**Santa Margarita River
Flood Control Project
MILCON Project P-010**

**Basilone Road Bridge
Replacement
MILCON Project P-030**

**United States Marine Corps
Marine Corps Base
Camp Pendleton, California**

**FINAL
ENVIRONMENTAL IMPACT STATEMENT**

Figure 2.3-1

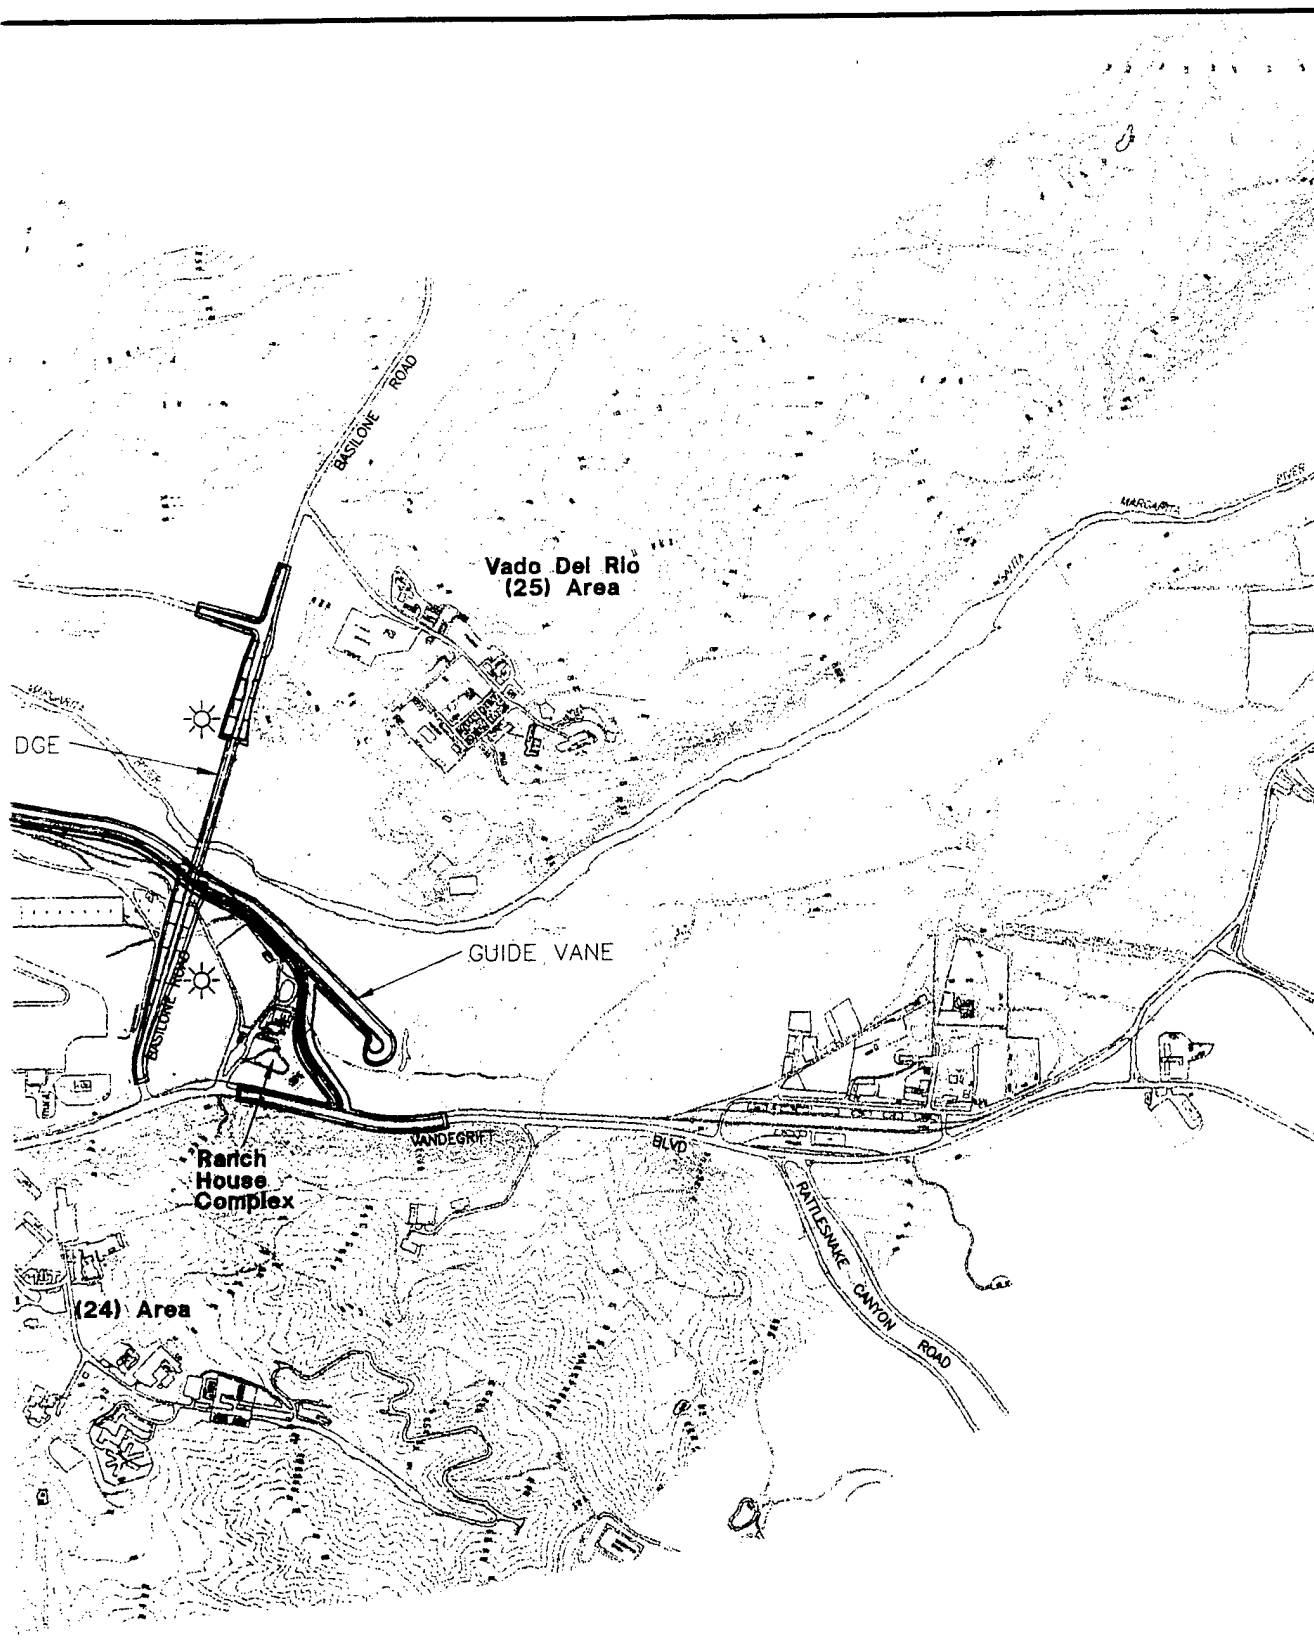
3.16	16	2-5	Fig 2.3-1	SPECIFIC COMMENTS Section 2.0 Proposed Action and Alternatives, 2.3 Alternatives to Implement the Proposed Action, Figure 2.3-1 "Alternative 3A-Preferred Alternative", Pg. 2-5. Since the storm water management system is a component of Alternative 3A, the FEIS should indicate the location of the existing earthen ditch, proposed pump station, and discharge point on this figure.	Comment noted. Figure 2.3-3 on page 2-9 provides an illustration of the existing earthen ditch with reference to the floodwall. Figure 2.3-4 is a detailed drawing of a plan view of the proposed pump station that includes identification of the outlet portion of that structure.

Section 2.0 Proposed Action and Alternatives, 2.3 Alternatives to Implement the Proposed Action, Figure 2.3-1 "Alternative 3A-Preferred Alternative", Pg. 2-5 Since the storm water management system is a component of Alternative 3A, the FEIS should indicate the location of the existing earthen ditch, proposed pump station, and discharge point on this figure.

Figure 3.3 - 2

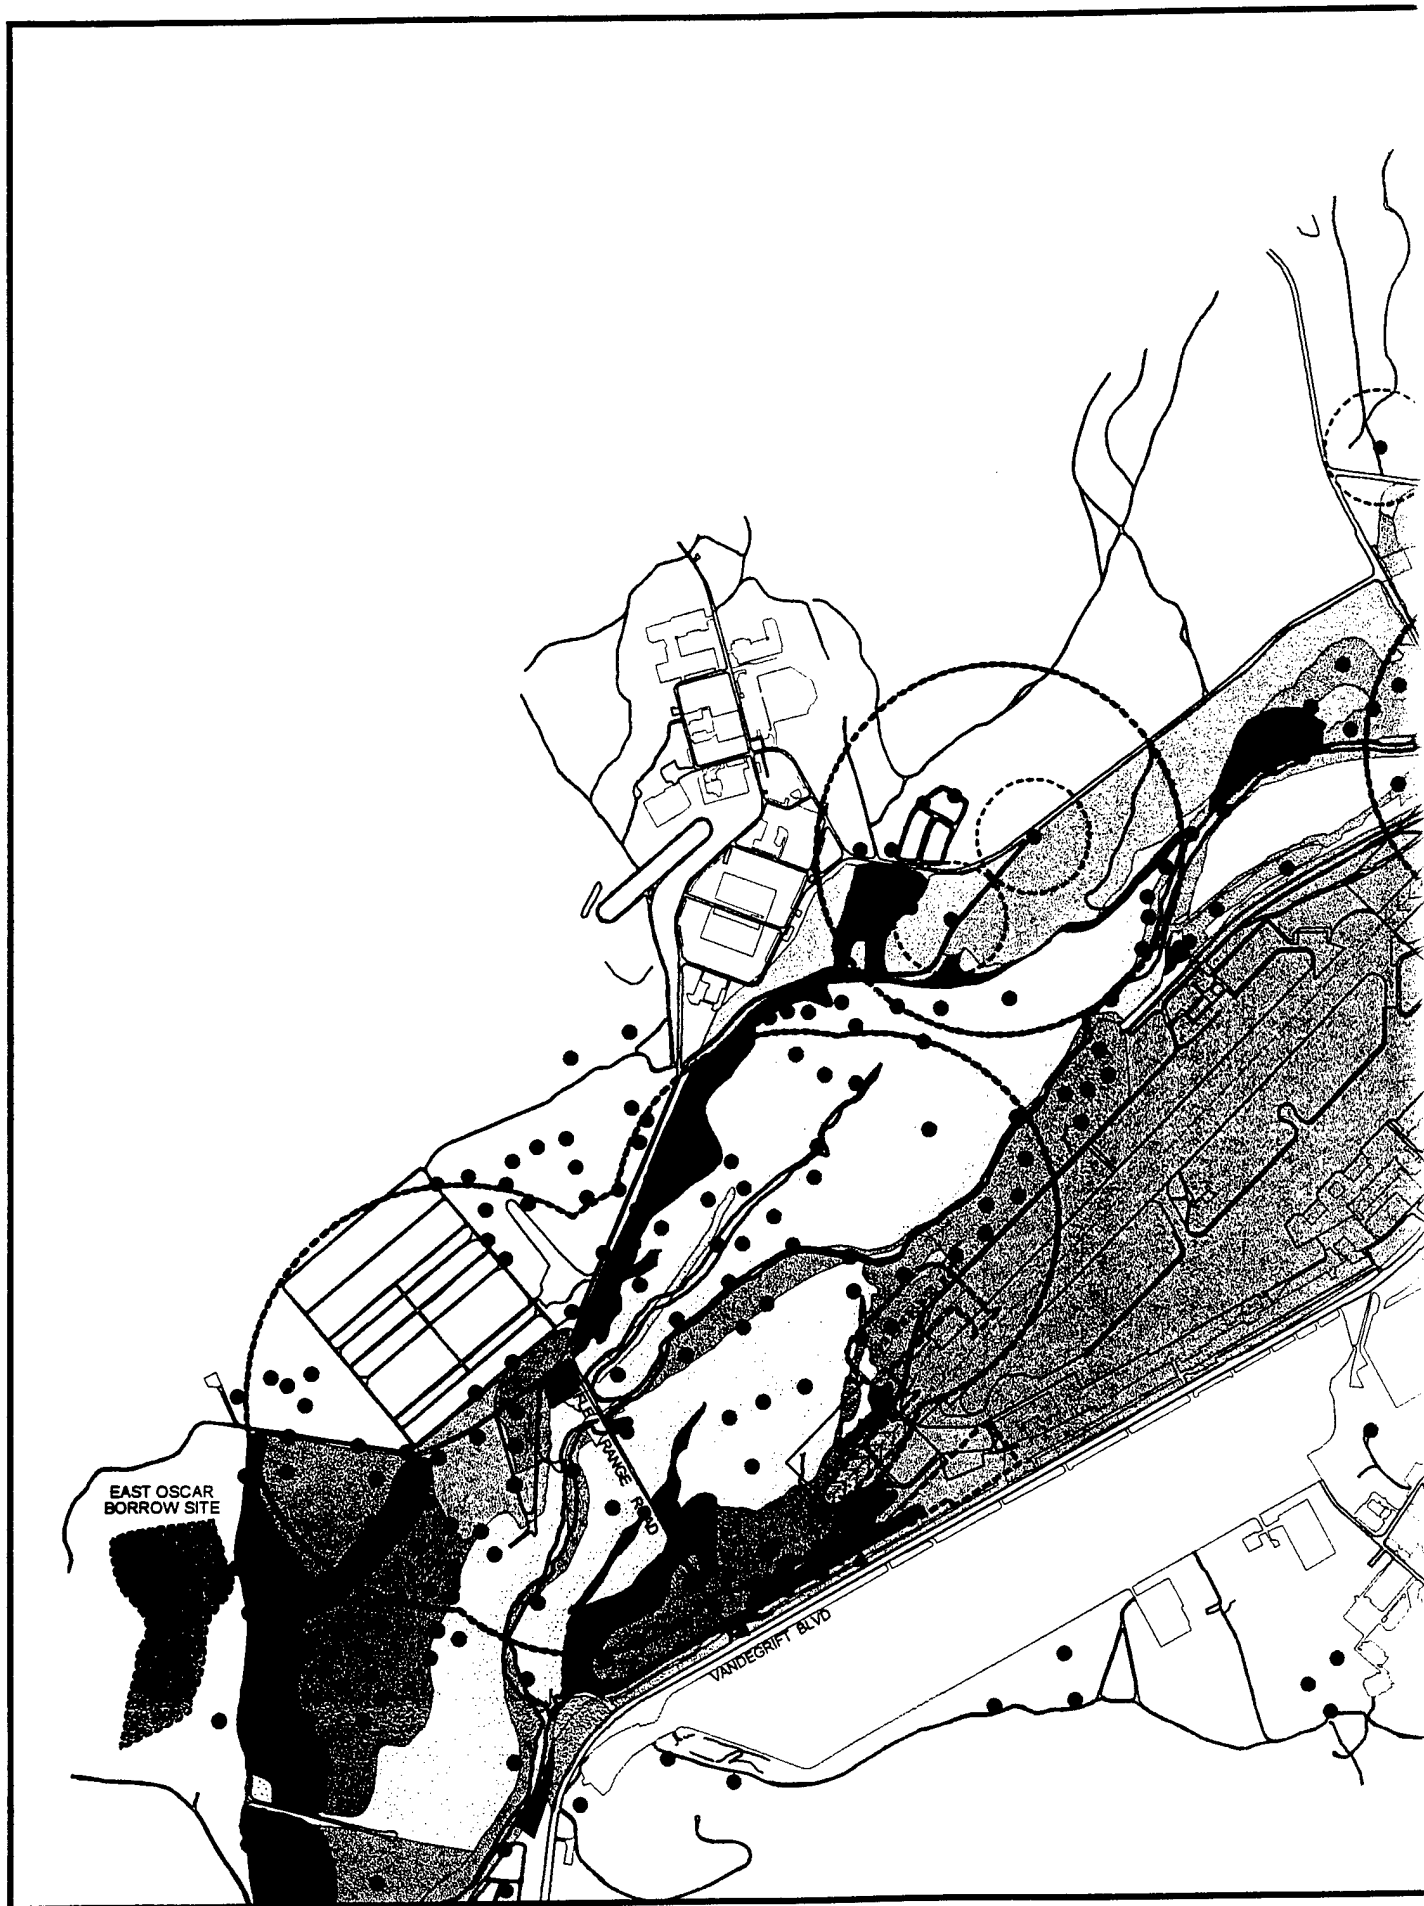
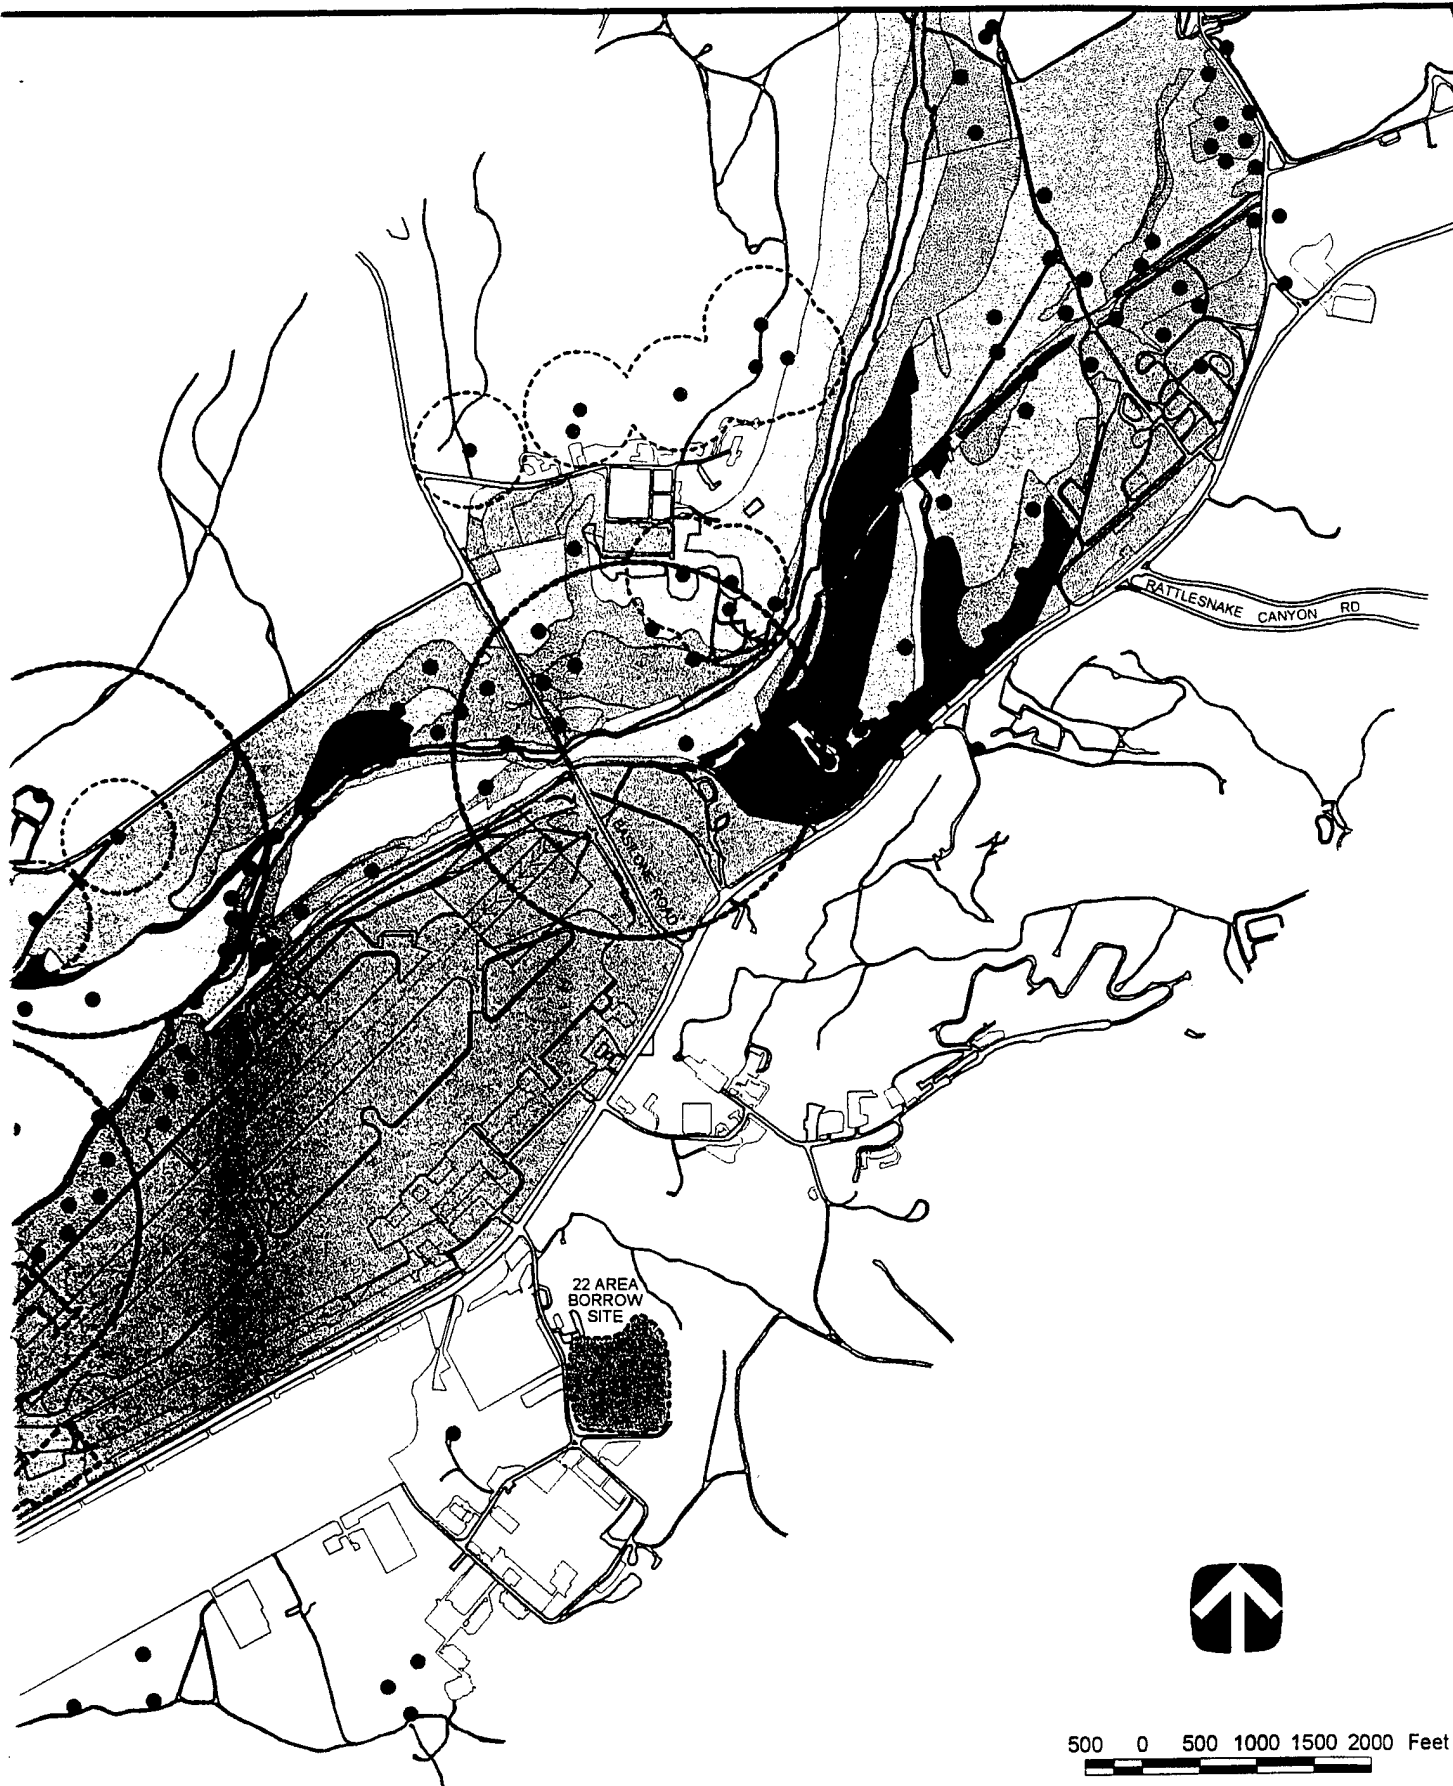
3.08	8	3.3-9	Fig 3.3-2	According to the DEIS, the preferred alternative levee/floodwall alignment footprint would occur primarily within areas designated as grass-forb and Arundo. However, based on the Service's review of 1994 aerial photographs, Status Report 2, and the location of federally listed species as shown in Figure 3.3-2 "Sensitive Species", there appears to be a discrepancy regarding the habitat communities found within the project area. For instance, three Flycatcher locations are identified within an area mapped as grass-forb (Figure 3.3-2). However, Status Report 2 and a review of 1994 aerial photographs indicate this area riparian woodland.	Comment noted. Figure 3.3-2 "Sensitive Species" has been revised to provide greater detail of habitat communities.

3.20	20	3.3-9	Fig 3.3-2	Section 3.0, Affected Environment, 3.3 Biological Resources, 3.3.3 Figure 3.3-2 "Sensitive Species", Pg. 3.3-9. Survey information regarding the occurrence of the California gnatcatcher within the area influenced by the proposed action should be included on this figure in the FEIS.	Comment noted.. A 1994 survey did not identify any California Gnatcatchers within the areas of influence of the proposed project. Only one Gnatcatcher was been found and it was outside the project area. As a result, no adverse impacts to this species would occur. The location of the individuals discovered during the survey is not shown on Figure 3.3-2 due to its scale.

According to the DEIS, the preferred alternative levee/floodwall alignment footprint would occur primarily within areas designated as grass-forb and Arundo. However, based on the Service's review of 1994 aerial photographs, Status Report 2, and the location of federally listed species as shown in Figure 3.3-2 "Sensitive Species", there appears to be a discrepancy regarding the habitat communities found within the project area. For instance, three Flycatcher locations are identified within an area mapped as grass-forb (Figure 3.3-2). However, Status Report 2 and a review of 1994 aerial photographs indicate this area as riparian woodland.

Section 3.0 Affected Environment, 3.3 Biological Resources, 3.3.3 Figure 3.3-2 "Sensitive Species", Pg. 3.3-9 Survey information regarding the occurrence of the California gnatcatcher within the area influenced by the proposed action should be included on this figure in the FEIS.

Figure 4.2-1

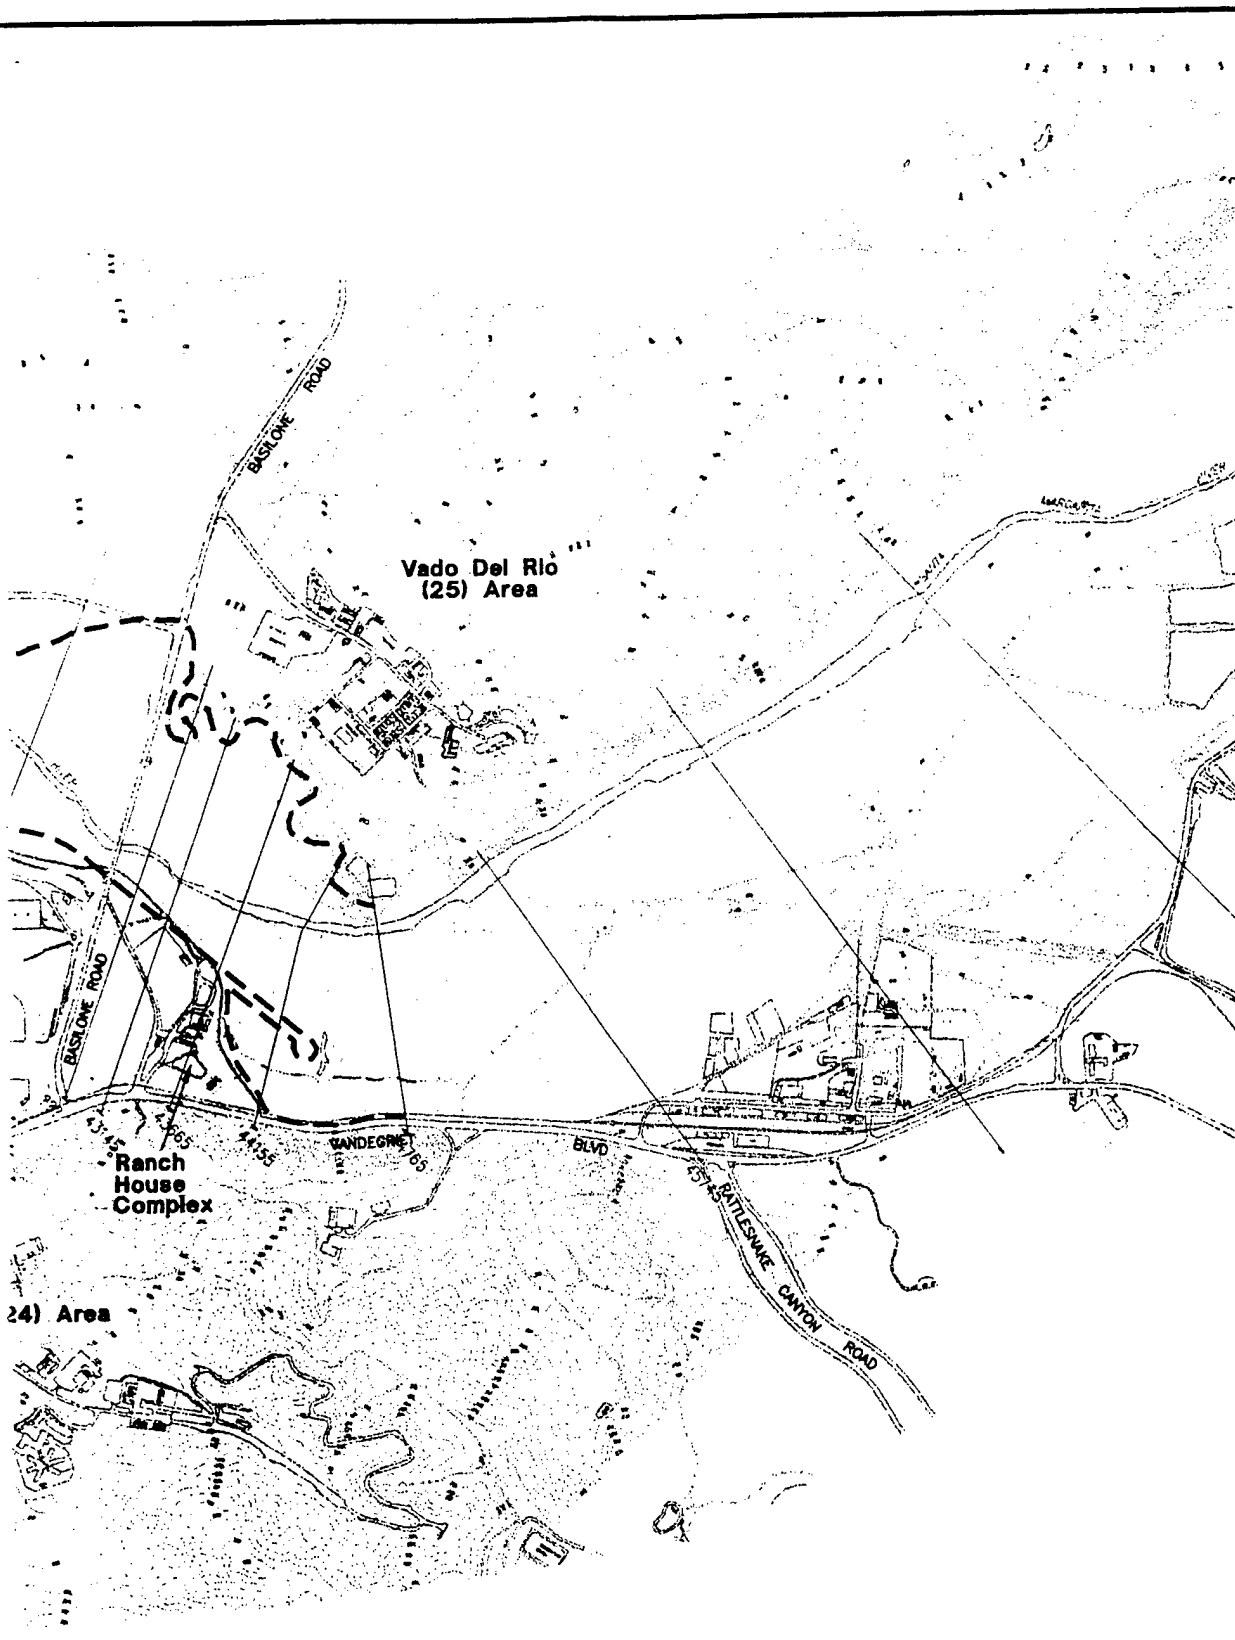
6.17	4	4.2-5	4.1.2.1	4. Page 4.2-5. Under Stormwater Management System it is not clear as to the location of the temporary inundation area "behind" the Chappo (22) area. This should be shown on Figure 4.2-1.	Comment noted. The inundation area is within the Chappo (22) area. Figure 1.2.2 has been edited to show the inundation area. This inundation area is an existing collection basin.
